ZONING COMMITTEE STAFF REPORT

1. **FILE NAME:** Archer Daniels Midland Co. **FILE #** 09-073-792
2. **APPLICANT:** Archer Daniels Midland Co. **HEARING DATE:** June 11, 2009
3. **TYPE OF APPLICATION:** Conditional Use Permit
4. **LOCATION:** 575 Drake St, area Southeast of Watson and Drake
5. **PIN & LEGAL DESCRIPTION:** 122823320012, SECTION 12 TOWN 28 RANGE 23 LOT 1 BLK 1 & LOT 1 BLK 2 NORTH WESTERN 1ST ADD & IN SD GOVT LOT 4 PART DESC AS BEG AT MOST WLY COR OF LOT 1 BLK 2 NORTH WESTERN ADD TH S 40 DEG 20 MN W 150 FT TH S 83 DEG 35 MN W 77 FT TH S 40 DEG 20 MN W 348.3 FT TO NELY COR
6. **PLANNING DISTRICT:** 9 **PRESENT ZONING:** I2, RC1
7. **ZONING CODE REFERENCE:** §61.501; §68.213; §68.214; §68.400; §68.402; §68.403; §68.404; §68.500; §68.501; §68.503; §68.504
8. **STAFF REPORT DATE:** June 4, 2009 **BY:** Sarah Zorn
9. **DATE RECEIVED:** May 18, 2009 **60-DAY DEADLINE FOR ACTION:** July 17, 2009

A. **PURPOSE:** Conditional use permit for addition to accessory structure in the floodway

Figure 5-6. Determining the conveyance shadow

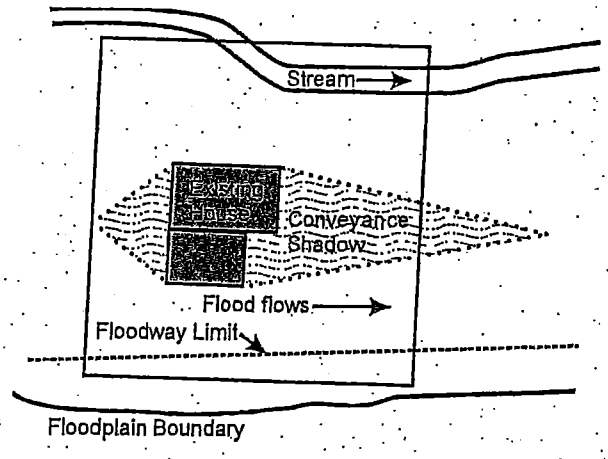
As we can see, the additional infrastructure amounts to approximately **39 cubic feet** of volume impact below the 711.0 elevation. This is equivalent to a 28" square column with a height of seven feet. Also, approximately half of the proposed enclosure is located within the conveyance shadow of the existing structure (see attached figure 1-1). Therefore, we consider the impact of this project to be very minor and too small to warrant an additional engineering study. Attached is information from the National Flood Insurance Program (NFIP) requirements (pages 5-23 and 5-24). This information supports this finding for minor projects such as this one.
